### ADMINISTRATIVE CONTROLS

## 6.0 ADMINISTRATIVE CONTROLS

FIGURE 6.2.1-1  
OFFSITE ORGANIZATION

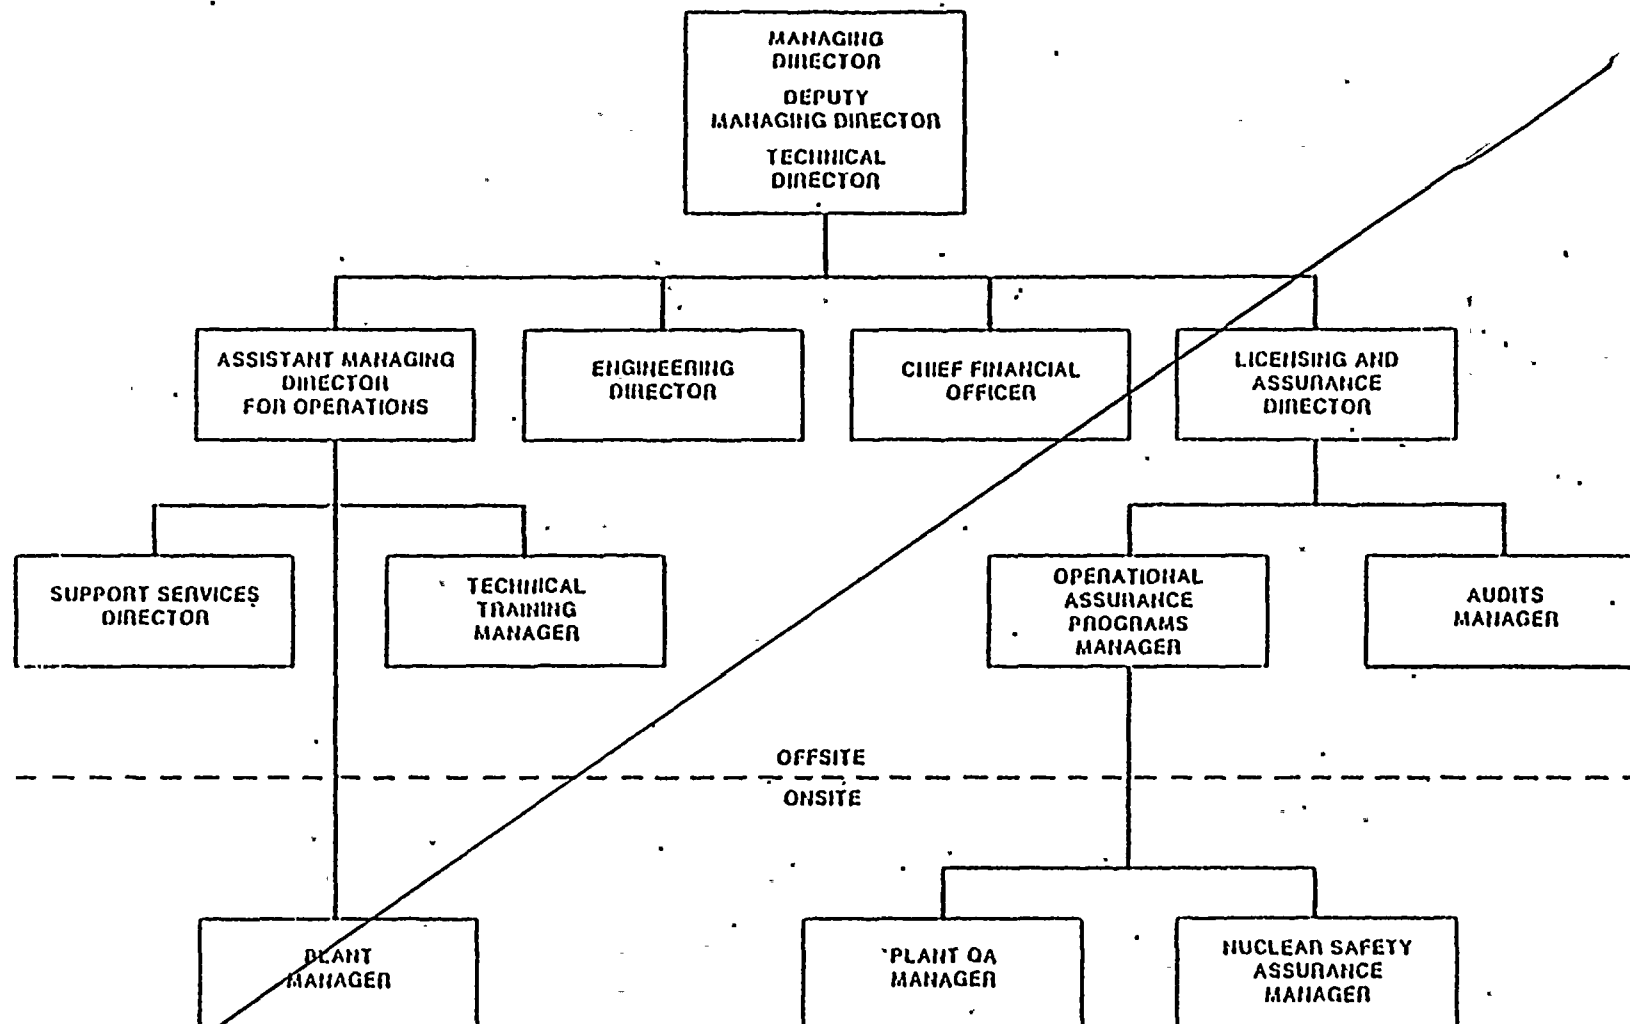
6.2.1 ~~The offsite organization for unit management and technical support shall be as shown on Figure 6.2.1-1.~~

INSERT

Onsite and offsite organizations shall be established for unit operation and corporate management, respectively. The onsite and offsite organizations shall include the positions for activities affecting the safety of the nuclear power plant.

FIGURE 6.2.2-1a  
UNIT ORGANIZATION

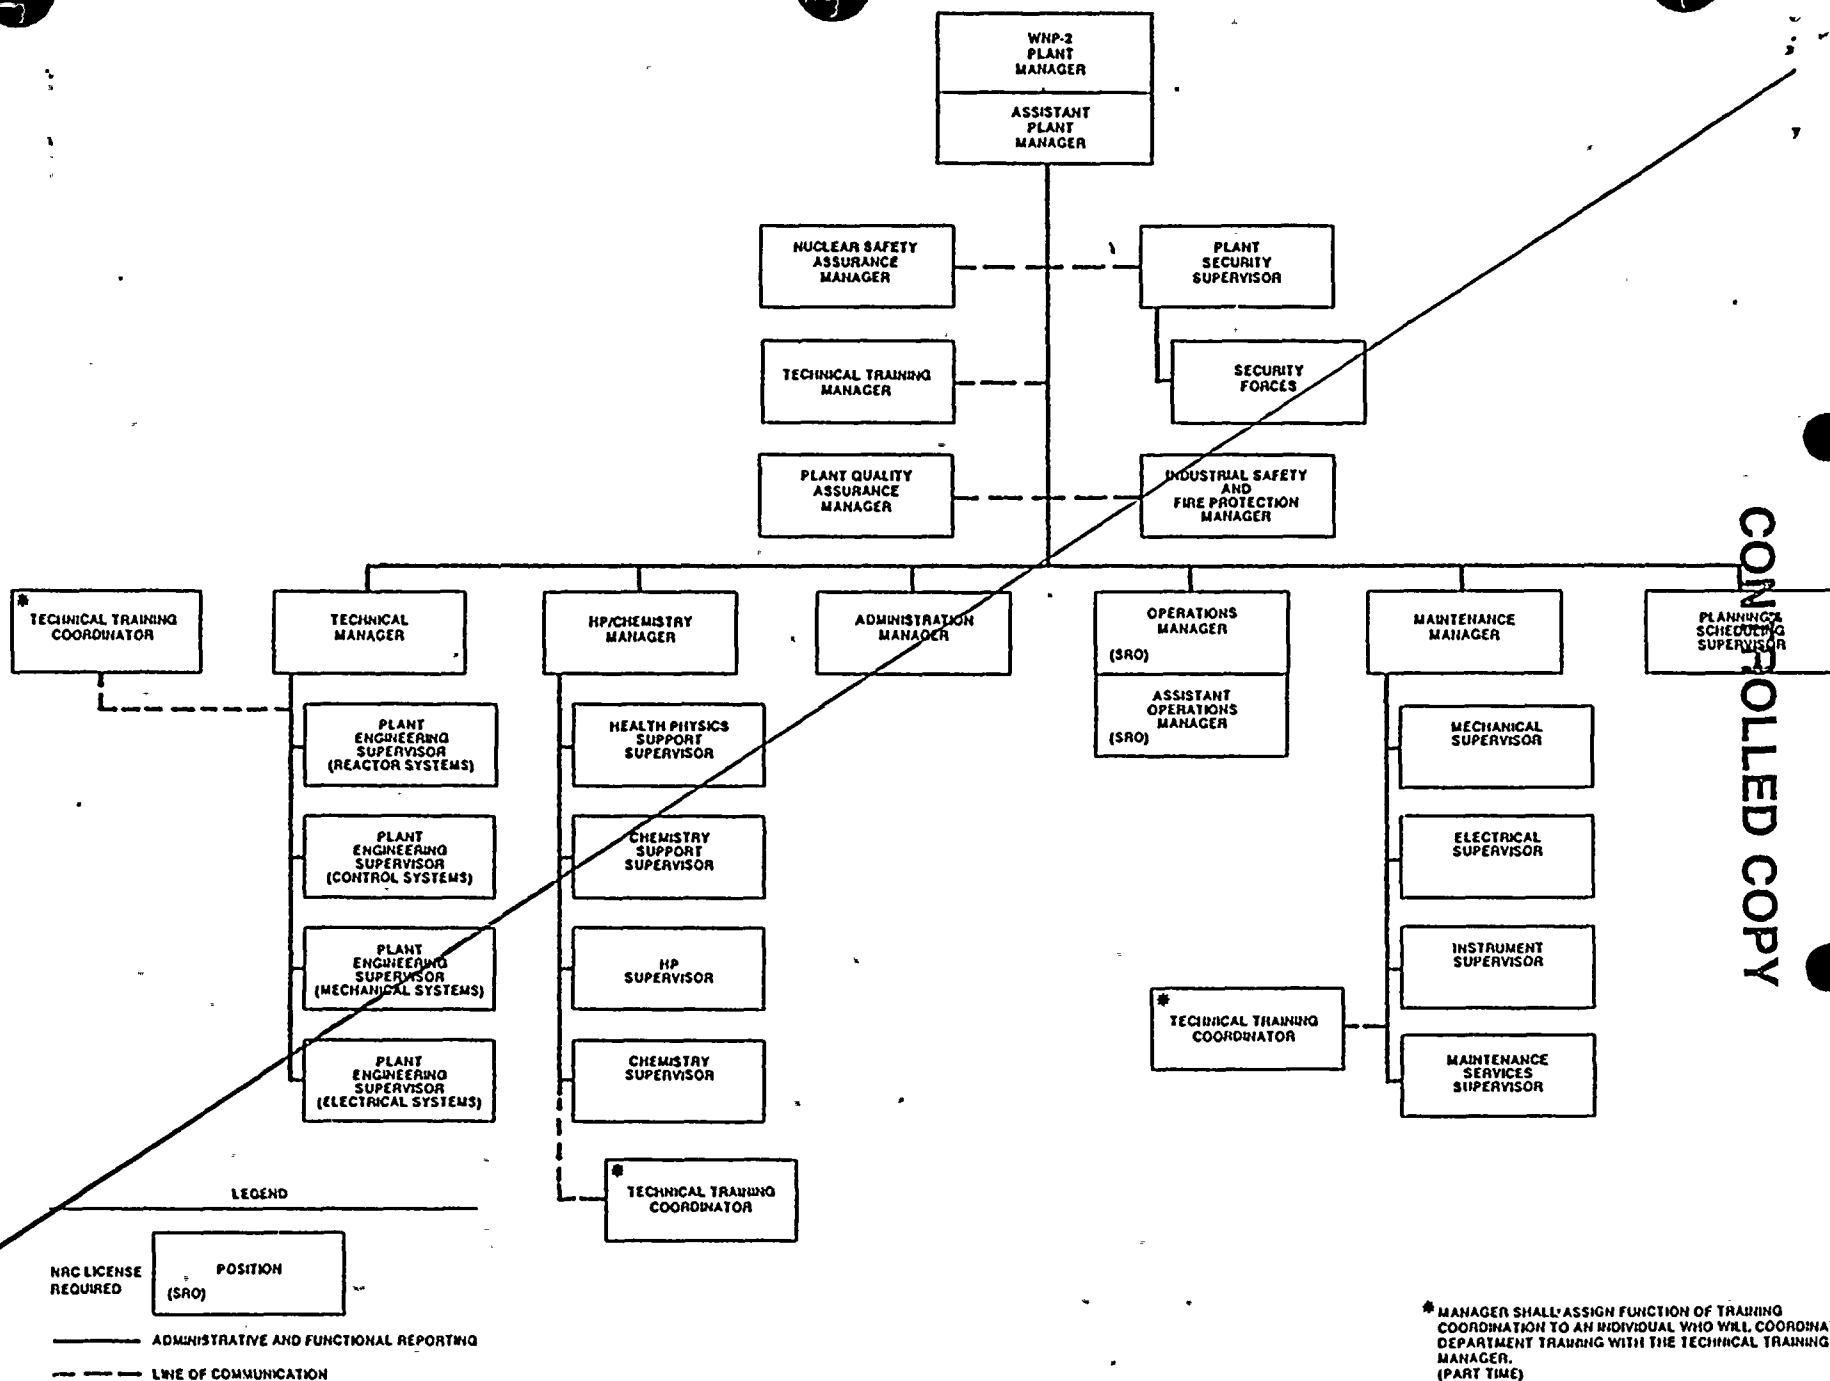
6.2.2 ~~The unit organization shall be as shown on Figures 6.2.2-1a and 6.2.2-1b, and:~~

- a. Lines of authority, responsibility, and communication shall be established and defined for the highest management levels through intermediate levels to and including all operating organization positions. These relationships shall be documented and updated, as appropriate, in the form of organization charts, functional descriptions of departmental responsibilities and relationships, and job descriptions for key personnel positions. These requirements are documented in the WNP-2 FSAR and updated in accordance with 10 CFR 50.71.
